Access Compliance Report

Public Rights-of-Way

(Curb Ramps)

Intersection ID: 49322	Main Street: OLD_HOUSE_CR	Cross Street: WHITEBEAM_WY	Location: E
ADA ID: 1CF1BD2E5E2E	Ramp Type: PerpDiag	Initial Pass/Fail: Fail	Overall Compliance: No
			Severity Score: 48.75

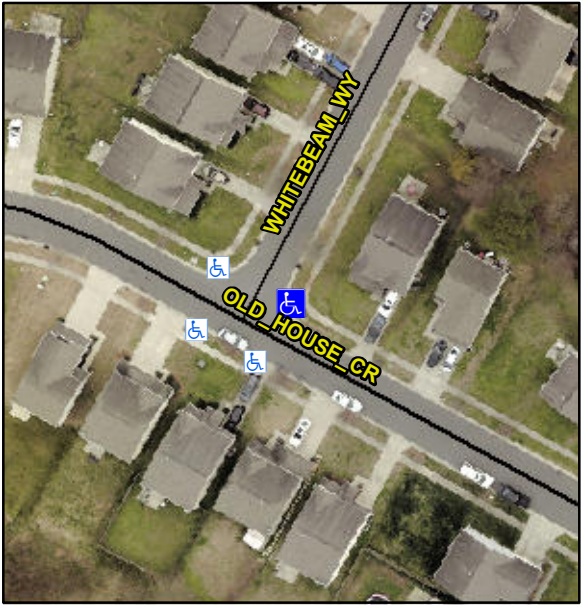
Codes/Mitigation Info/Possible Solution			Field Measurements/Component Compliance		
	Possible Solutions:		Compliance	Description	Data
	Remove & Replace Curb Ramp With Two New Directional Ramps or Equivalent.		No	Ramp Length (in)	67.0
			No	Ramp Width (in)	31.0
			N/A	Flare Type LT	N/A
			N/A	Flare Slope LT (%)	N/A
			N/A	Flare Traversable LT?	N/A
			N/A	Landing Length (in)	N/A
			N/A	Landing Width (in)	N/A
			N/A	Landing Slope (%)	N/A
			N/A	Landing X Slope (%)	N/A
			N/A	Landing Curb? (Y/N)	N/A
			N/A	Shared Landing?	N/A
			N/A	Gutter Ponding?	N/A
			N/A	Gutter Lip Ht (in)	N/A
			No	Painted X Walk1?	No
				X Walk 1 Direction	To NW
			N/A	X Walk 1 Width (in)	N/A
				X Walk 1 Slope (%)	2.3
				X Walk 1 X Slope (%)	2.4
			N/A	Ramp inside XWalk1?	N/A
<p>Surveyor Notes:</p> <p>N/A</p> <p>PROW/ADA:</p> <p>R304.5.1, R304.2.2, R304.5.3</p>			N/A	Flare Type RT	N/A
			N/A	Flare Slope RT (%)	N/A
			N/A	Flare Traversable RT?	N/A

N/A	DWS Provided?	N/A
			N/A	DWS Contrast?	N/A
			N/A	DWS Length (in)	N/A
			N/A	DWS Full Width?	N/A
			N/A	DWS Offset (in)	N/A
			N/A	Gutter Slope (%)	N/A
			N/A	Gutter X Slope (%)	N/A
			N/A	Painted X Walk2?	No
				X Walk 2 Direction	To SW
			N/A	X Walk 2 Width (in)	N/A
				X Walk 2 Slope (%)	1.0
				X Walk 2 X Slope (%)	2.6
			N/A	Ramp inside XWalk2?	N/A
			N/A	Clear Space?	N/A
			N/A	Clear Space to XWalk (in)	N/A
			N/A	Storm Grate/Utility Hazard?	N/A
				Storm Grate/Utility Type	
<p>Total Cost:</p> <p>\$ 3200.00</p>			N/A		N/A
			Yes	Surface Condition? (G/P)	Good
